Technical Service Bulletin

21 Mil on - P0299 Negative pressure deviation, turbocharger excessive wastegate play

21 13 14 2031245/5 June 7, 2013. Supersedes Technical Service Bulletin Group 21 number 13-13 dated April 4, 2013 for reasons listed below.

Figure 1. Fit the clip from the side.

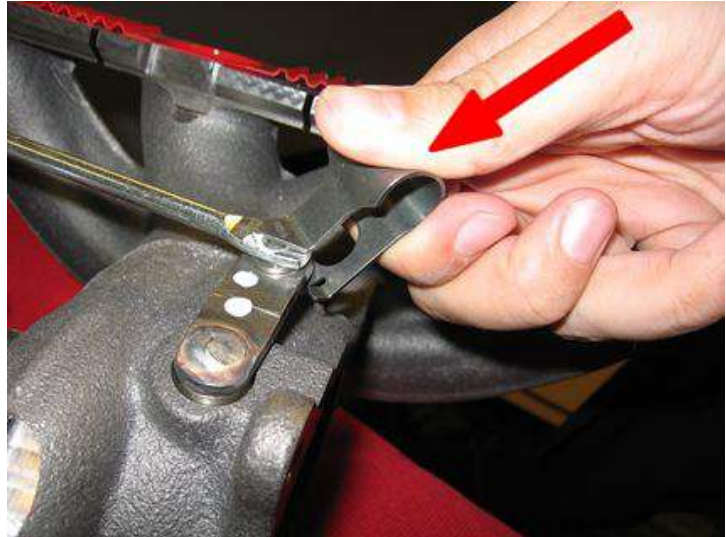
1. Remove turbocharger as per ELSA instructions: *Repair Manual >> Engine / Engine Mechanical >> 21 Turbocharger, G-Charger >> Removal and Installation >> Turbocharger.*
2. Install clip **06J145220B** on a replacement turbocharger's link plate and actuating rod joint as illustrated (Figures 1 and 2).

Figure 2. Turn the clip counter clockwise till the lugs slot in.

Figure 3. (1) Maximum opening of clip, (2) Position of original circlip

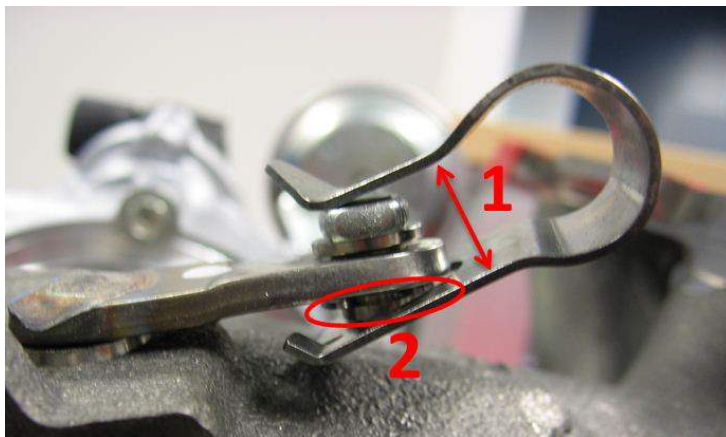
- The spring clip must not be overstretched. The maximum opening of the spring clip is 14 mm (Figure 3, 1).
- The spring clip must be replaced after every removal.

Figure 5. (1) Maximum opening of clip, (2) Position of original circlip

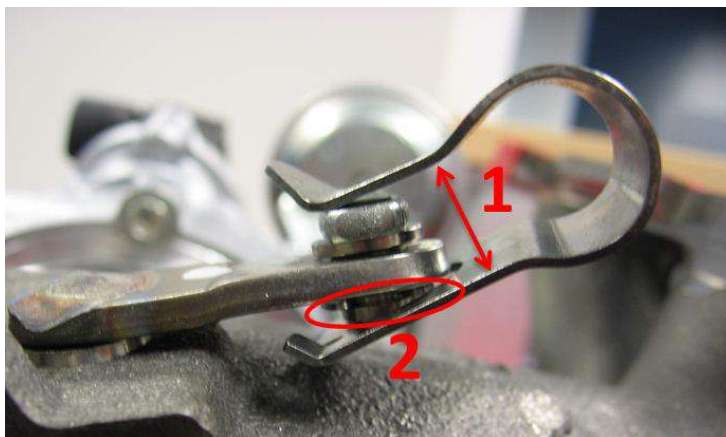
4. After fitting the spring clip, check the position of the original circlip (Figure 5, 2) and correct it if necessary.
